**EMAIL RE: FLOW VISUALIZATION
AND FLOW PATHS**

From: Gaines, Roger A MVM
Sent: Friday, August 16, 2002 7:46 AM
To: Davinroy, Robert D MVS
Subject: RE: Ice Photos

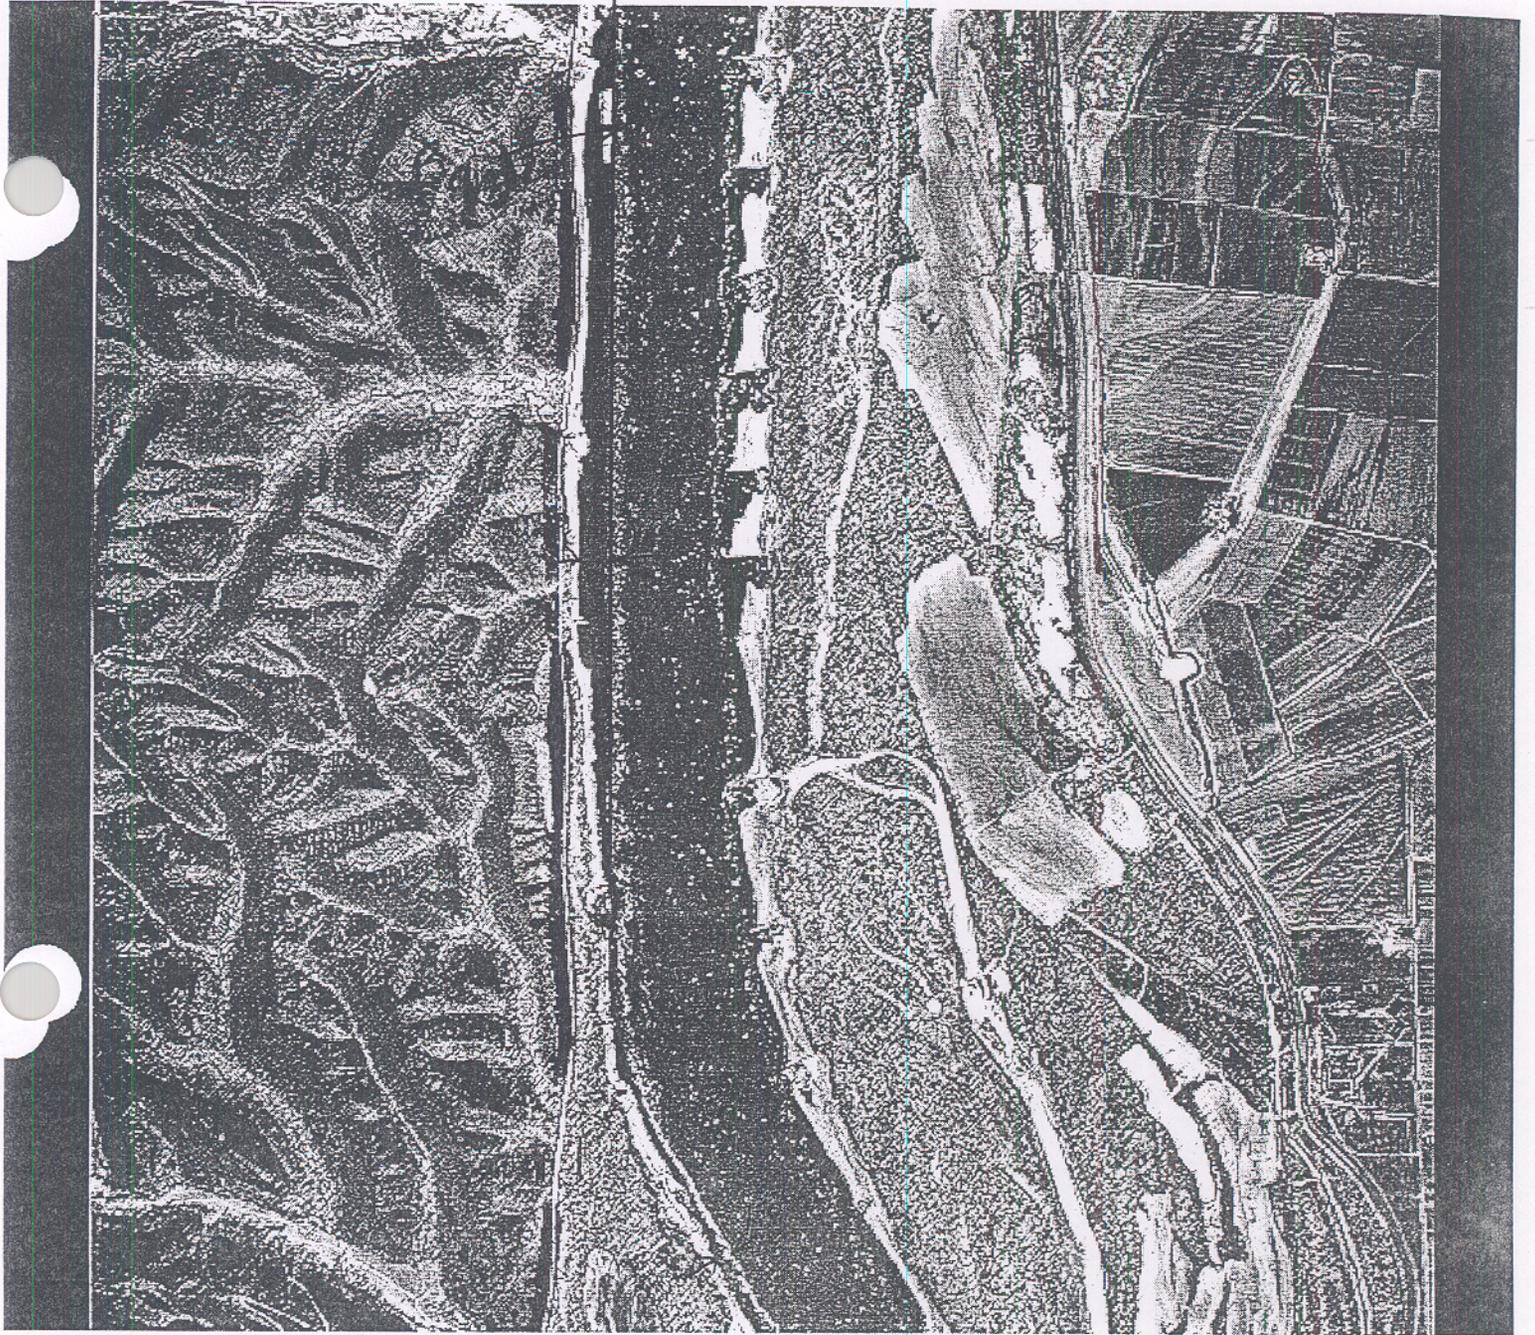
Figure 1 (photo has no label shown) -- ~RM135.
average flow width approx. 1600-1750 ft.

separation between RDB and ice trace: 250 ft. to 350 ft. max (center if image) to ~150 ft. (lower 1/3 of image). Ice trace follows a nearly straight line from upper edge of the photo to about 9500 feet downstream -- where the leftward bend in the channel occurs. Bank in the area sags behind a line projected along a "smooth" line of curvature.

separation between LDB and ice trace (this is heavily influenced by the contraction imposed by a long sequence of relatively closely space dikes): ~ 0 to 100 ft. from dike ends

Bank alignment and bank slope have an influence on how closely the main thread of velocity (defined by the ice floe) approaches the water's edge.

The barge (looks like a barge in the upper part of the photo, but image is pixelated so identity unknown) significantly influences the position of the ice trace over the upper 1/2 of the image along the RDB.

I-16-99

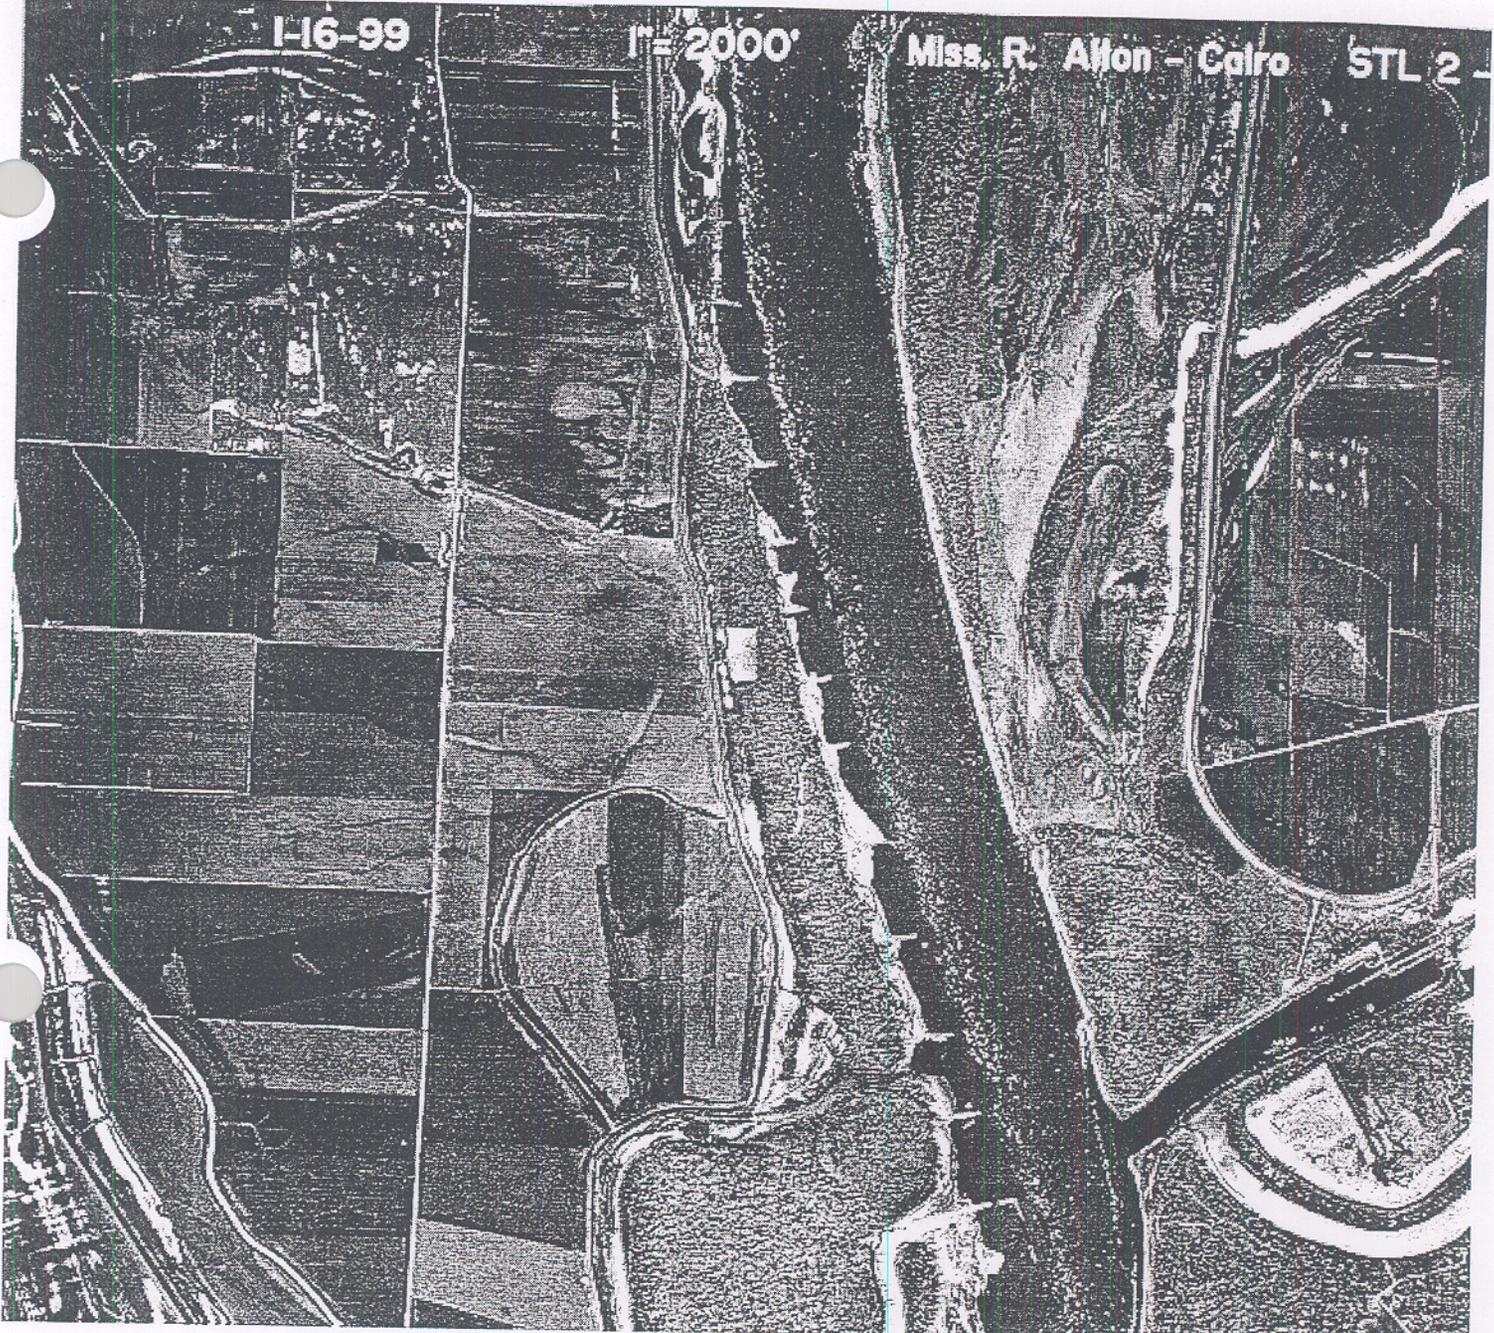
Figure 2 (photo is labeled 1-16-99 STL 2-something) -- mouth of Kaskaskia River reach

average flow width approx. 1600 ft.

separation between RDB and ice trace: ~150-250 feet from end of dikes. ~ 150 feet from RDB at upper edge of image. Separation heavily influenced by the contraction imposed by the long sequence of dikes along this bank. The sag in the bank line ~350 ft. from top of image also seems to have a major influence on the position of the ice floe.

separation between LDB and ice trace: Except in lower 1/3 of image, the ice seems to hug the bank. Although there is only a minimal amount of ice along this bank, its presence adjacent to the bank indicates very little boundary influence. The deflection of the ice trace near the lower edge of the photo (just upstream of the Kaskaskia River is influenced by a feature that cannot be determined at this image resolution/scale -- perhaps it is a boat tied up at this point. Position of the ice flow at and below the Kaskaskia River are influenced by the tributary outflow (suggested by the surface irregularities in the tributary).
